Fermoy Housing Development at
Cork Rd, Fermoy Co. Cork

Stage 1 Road Safety Audit

January 2022

Figure 2.1.

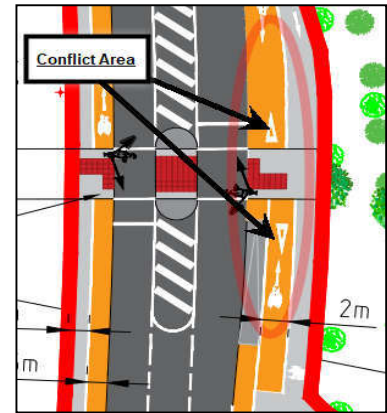
The proposed cycle lane as shown in Figure 2.1 could create confusion between pedestrian and cyclists at this locations. Failure to provide consistent and a streamlined design could lead to collisions and conflict between pedstrains and cyclist travelling in various directions. See Figure 2.1.

As there are no cycling facilities proposed as part of the development, the design team should consider providing a shared facility at this location.

Figure 2.4

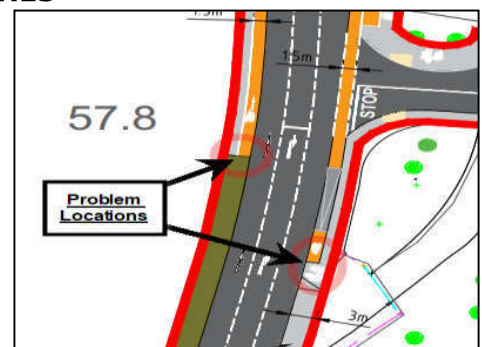
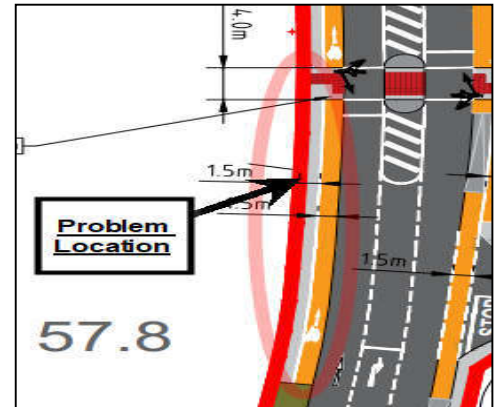
No details have been provided as to how cyclist will join and exit the proposed cyclelane to the south of the junction. Inadequate details at these locations could lead to collisions between cyclists and vehicles along R639. Refer to Figure 2.4

Provide connection details between the proposed cycle lanes and the R639
